April 21, 1993
LD-93-069

Subject: System 80+TM Information for Issue Closure

The attachments to this letter provide markups OF CESSAR-DC for closure of DSER issues. These markups, and others to be discussed with NRC staff in forthcoming meetings, will be printed as part of Amendment 0 in May, 1993.

ATTACHMENT 1

TABLE 11.2-6

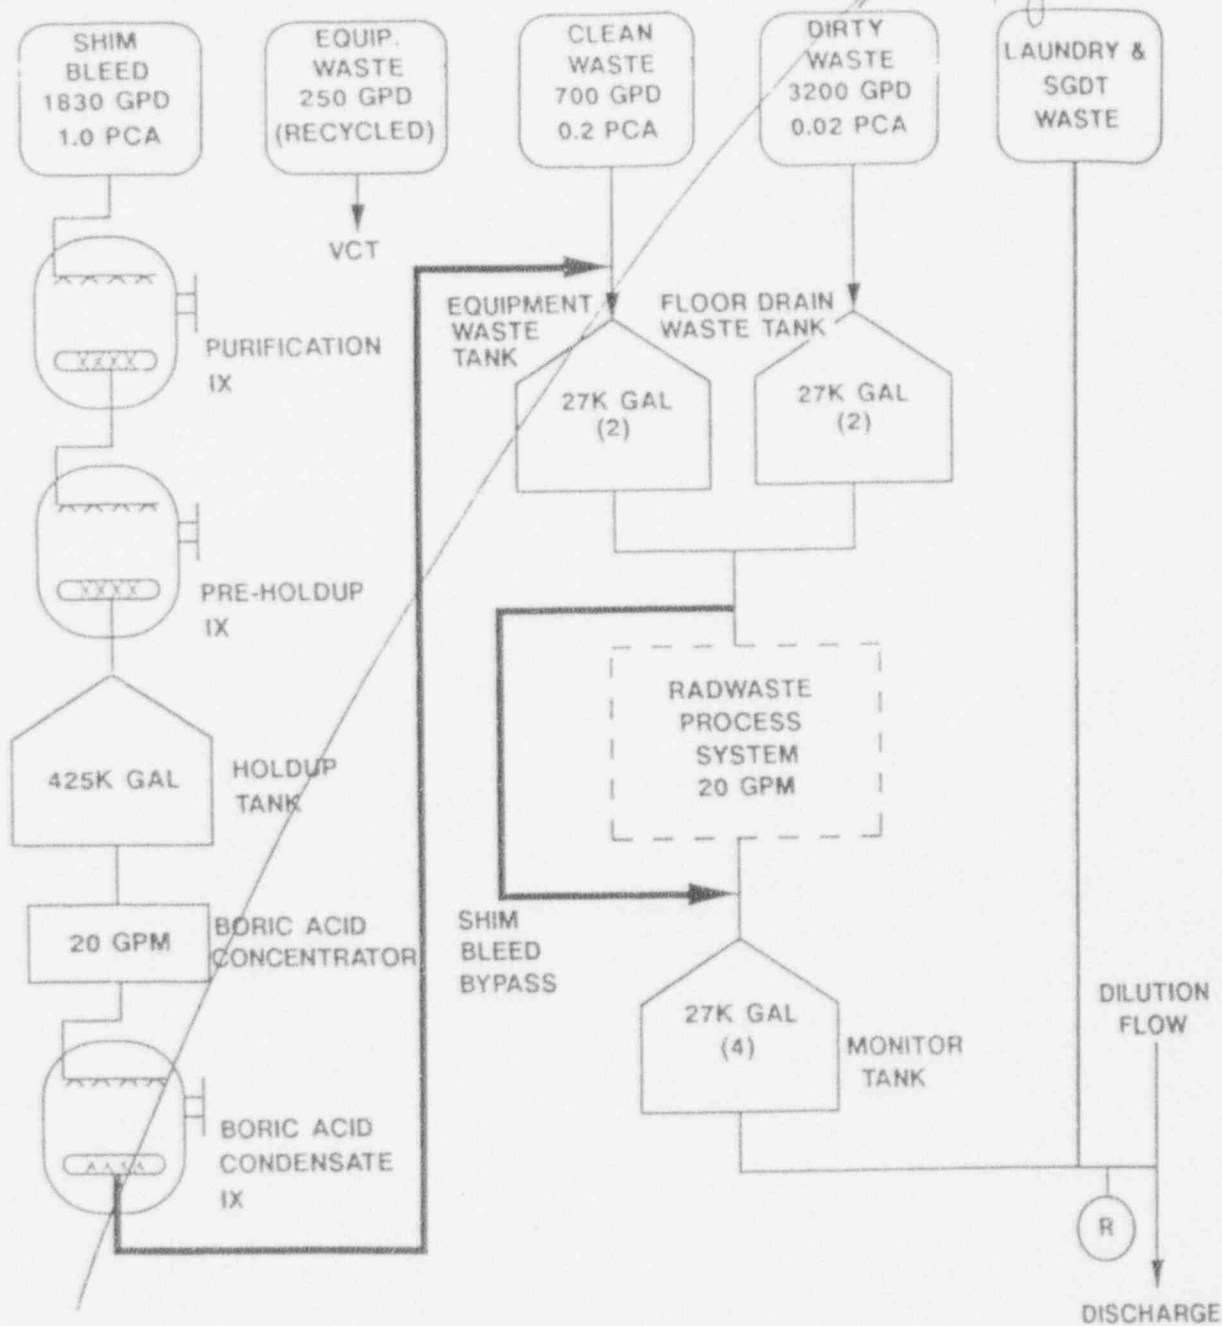
CESSAR DESIGN
CERTIFICATIONTABLE 11.2-5 (Cont'd)
(Sheet 2 of 2)DESIGN BASIS AVERAGE DAILY LIQUID
EFFLUENT CONCENTRATION (a)

Figure 11.2-2

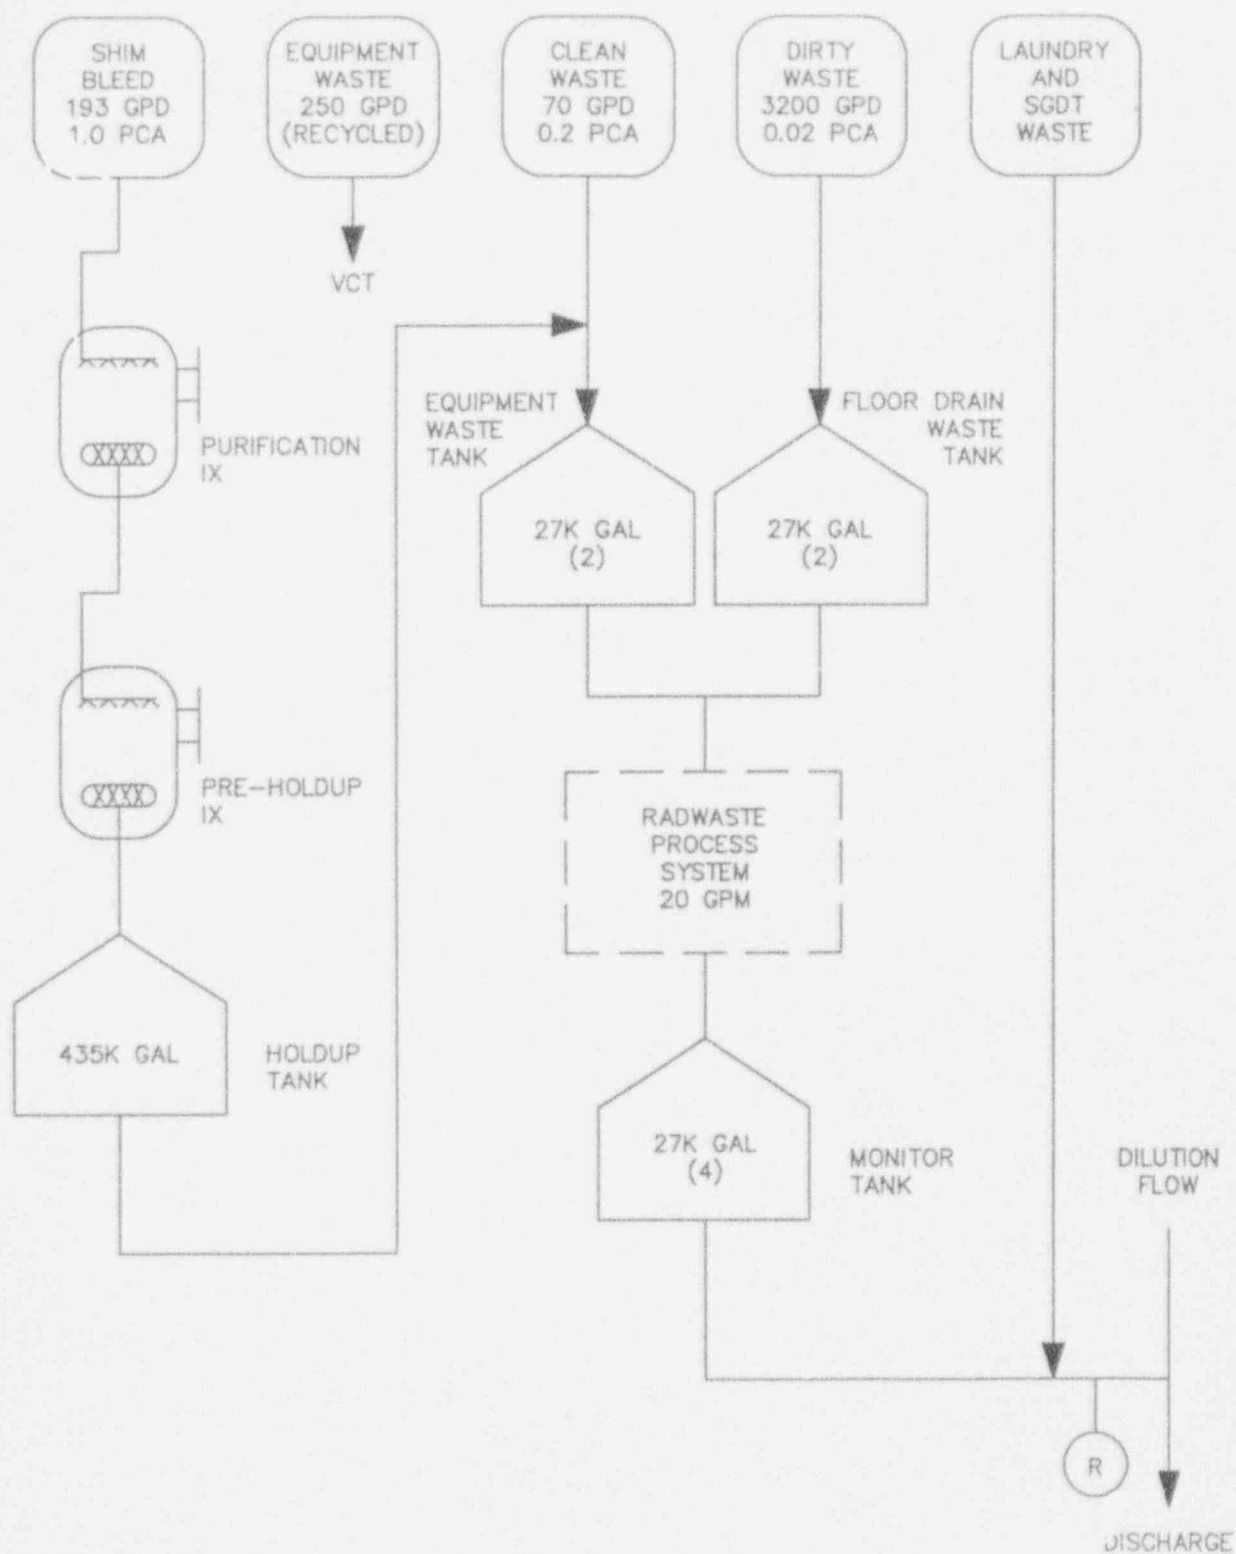
Normal Operating Average Annual Liquid Effluent Concentration

(Delete this table)
